REQUEST

Current Zoning: R-3 (single family residential)
Proposed Zoning: UR-2(CD) (urban residential, conditional)

Approximately 4.81 acres at the intersection of Marvin Road and Old Ardrey Kell Road, on the eastern side of Johnston Road.

The petition proposes redevelopment of 6 single family homes for a single family attached development with up 42 units at a density of 8.7 units per acre.

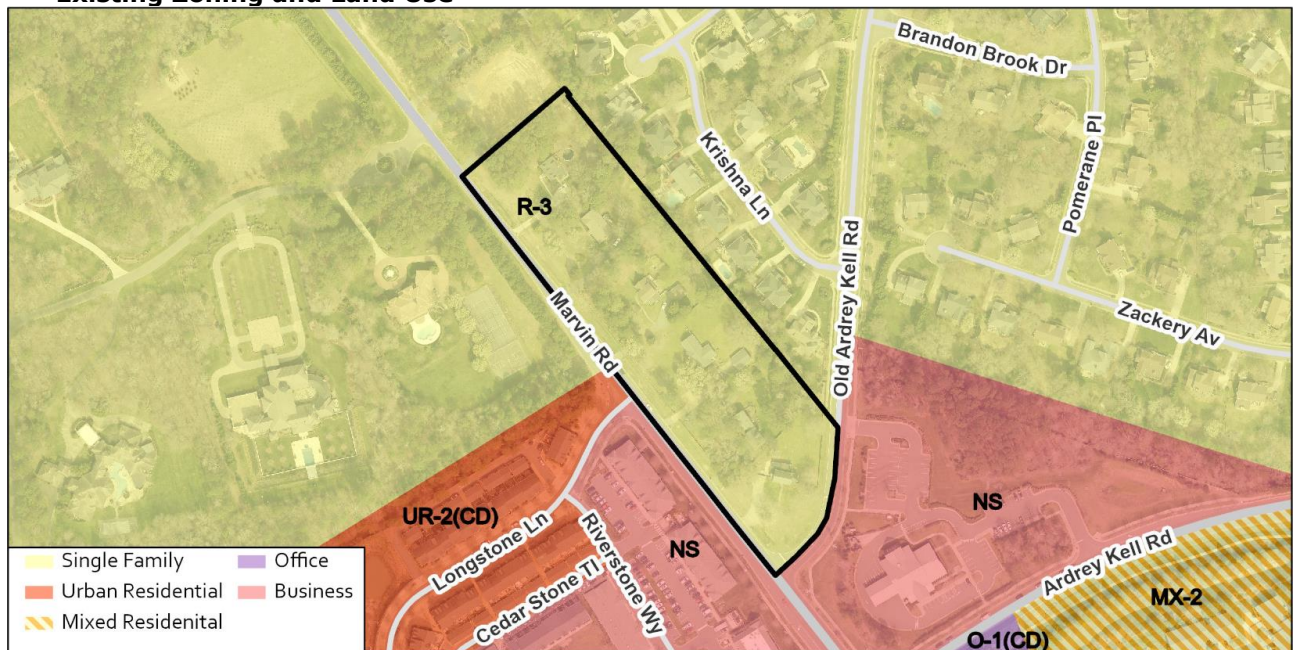
1. Amend the site plan to provide masonry screen walls and landscaping at the end of each private alley facing the public streets. Addressed
2. Provide setbacks from Marvin and Old Ardrey Kell Roads as measured from future back of curb. The setback along both frontages should reflect the location of the buildings depicted on the plan, not the Ord. minimum. Addressed
3. Annotate the concept renderings to point out key features of the proposed building design. Addressed

4. Show space for solid waste and recycle receptacles even if private, rollout collection is planned. Addressed
5. Amend note H.1 to specify a minimum size for open space areas. Addressed

8. Based on feedback from the community, please revise the dimension of the concrete island proposed on Old Ardrey Kell Rd. to allow room for more left turn storage at the Old Ardrey Kell and Marvin Rd. intersection.

9. Clarify in the notes that tree save area is to be "preserved" replanted tree save is not an option.
10. Amend the label for the buffer/tree save area to state "Preserved Tree Save" and that within the buffer/tree save area where preserved trees do not exist to meet the buffer standard additional plantings will be provided such that the buffer meets a Class C standard.
